# Environmental Re-evaluation #6

**NEPA RE-EVALUATION 6**

**Supporting Documentation**

**August 28, 2024**

Figure 2. I-20 / Bush River Road Interchange

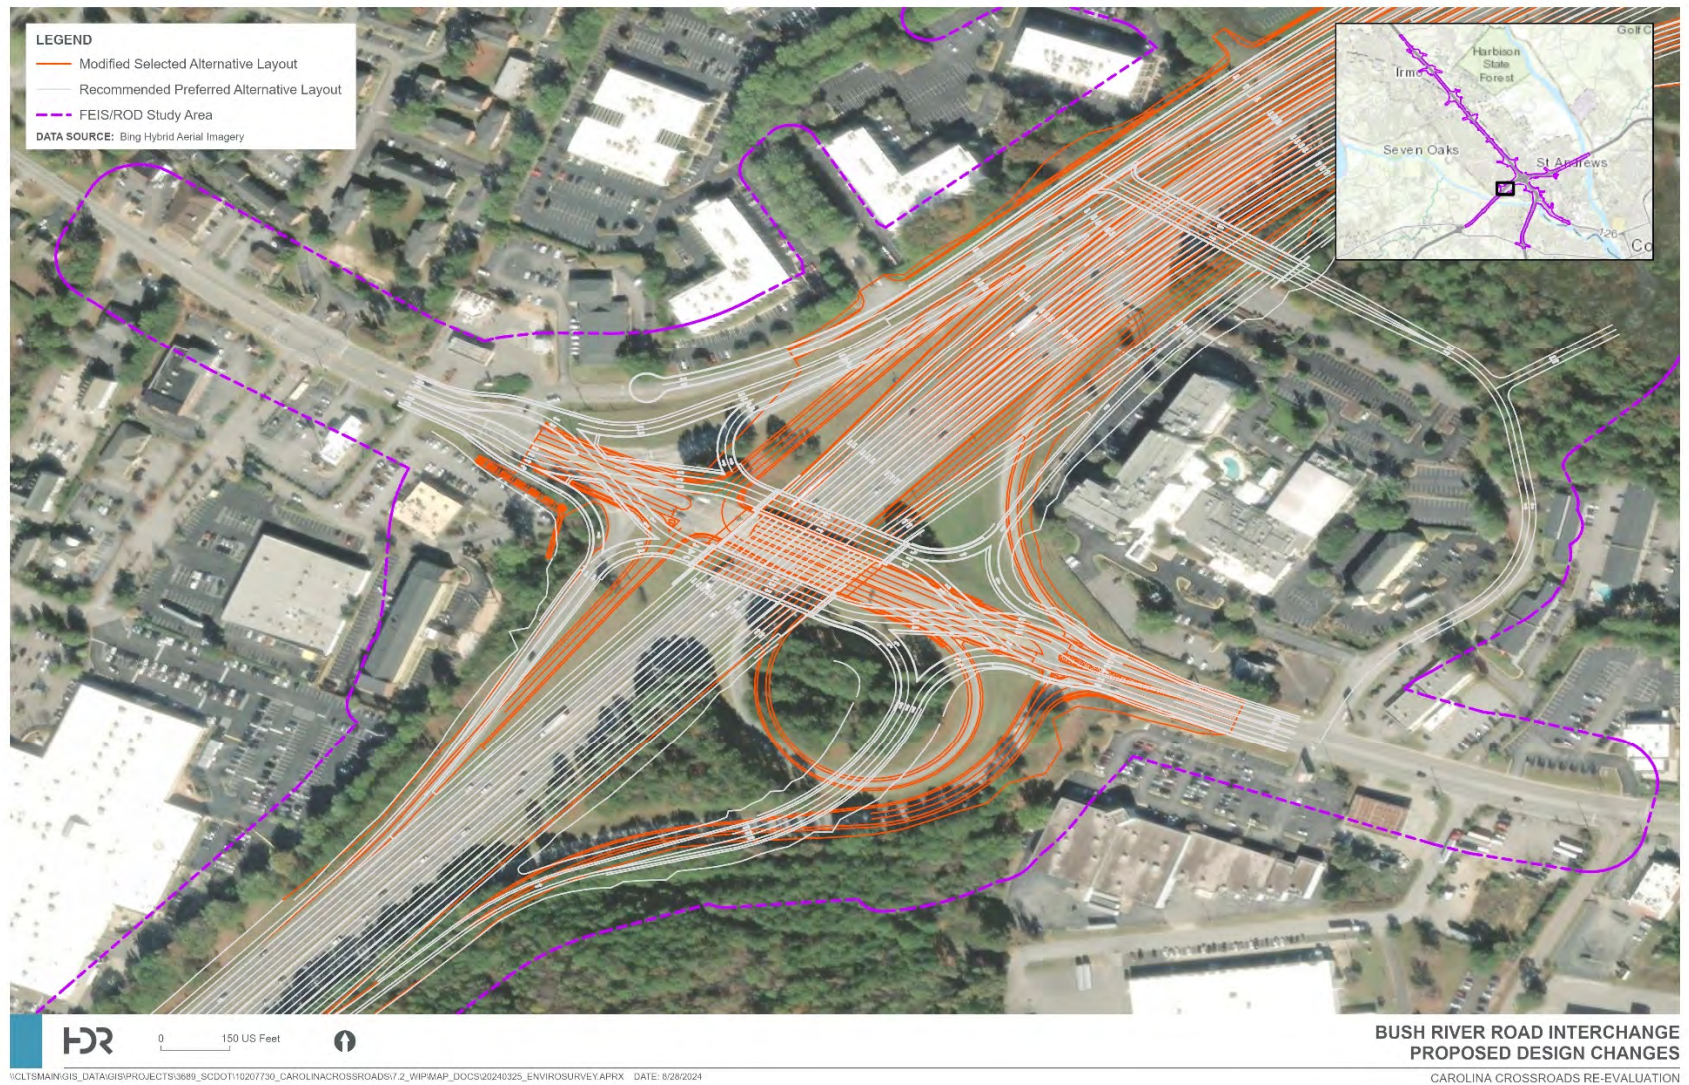
The RRPA originally proposed a diverging diamond design at the I-20 / Bush River Road interchange with an overpass across I-20 connecting Berryhill Road to Rockland Road. In efforts to improve constructability and minimize impacts to surrounding businesses, an alternative design was considered. The revised design would maintain the existing partial cloverleaf (parclo) configuration (No-build alternative in the EIS), and make improvements to ramps, intersections, and turn-lane storage thereby improving traffic operations and efficiency (Figure 2).

The revised design is within the previous project study area (PSA) and right-of-way has already been acquired. As a result of these design changes, there would be no change in impacts at this location. No other studies documented in the FEIS/ROD required updating as a result of this design change.

Figure 3. Berryhill Road Realignment

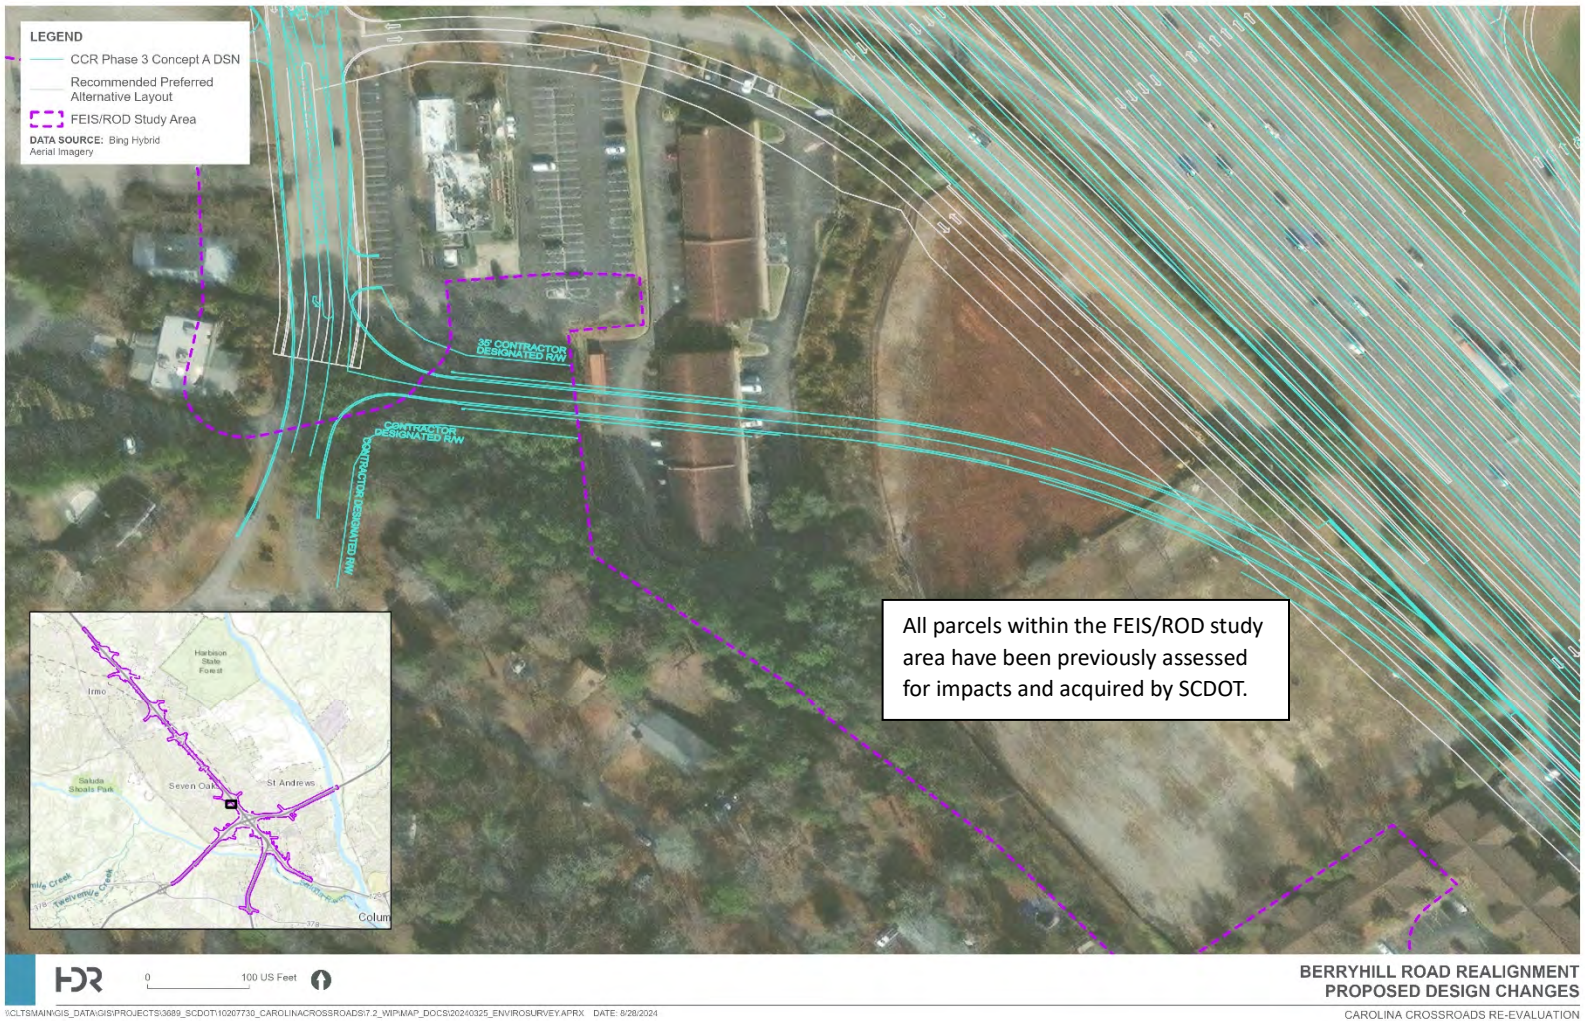
The RRPA did not make any adjustments to the alignment of Berryhill Road. An alternative design was developed which realigned Berryhill Road for approximately 750 feet through vacant parcels to its intersection with Woodland Hill Road. The realignment would relocate the existing intersection 350 feet further away from the Woodland Hill Road and St. Andrews Road intersection thereby increasing the intersection spacing by simplifying movements at the two intersections which also improves safety. In addition, the relocated Stoops Creek crossing will accommodate a bridge crossing and provide more room for utility relocations. (Figure 3).

The re-alignment of Berryhill Rd would impact three parcels outside of the FEIS/ROD PSA including Parcels 632, 633 and 634 (see Figure 3). The alignment crosses the southernmost boundary of Parcel 632 across a paved, parking lot behind the restaurant building. The alignment also crosses the northernmost boundary of Parcel 633 across a previously excavated, wooded area. Curb and drainage improvements along Woodland Hills Road could impact a minor amount of Parcel 634 along its western boundary; final amount of impacts would be dependent on the design proposed under Phase 3A.

In addition, the realignment of Berryhill Road from the FEIS alignment reduces the distance of the roadway to nearby residential receptors within noise sensitive areas (NSA) K to less than half of its original distance, so noise levels at those receptors were reanalyzed in TNM.
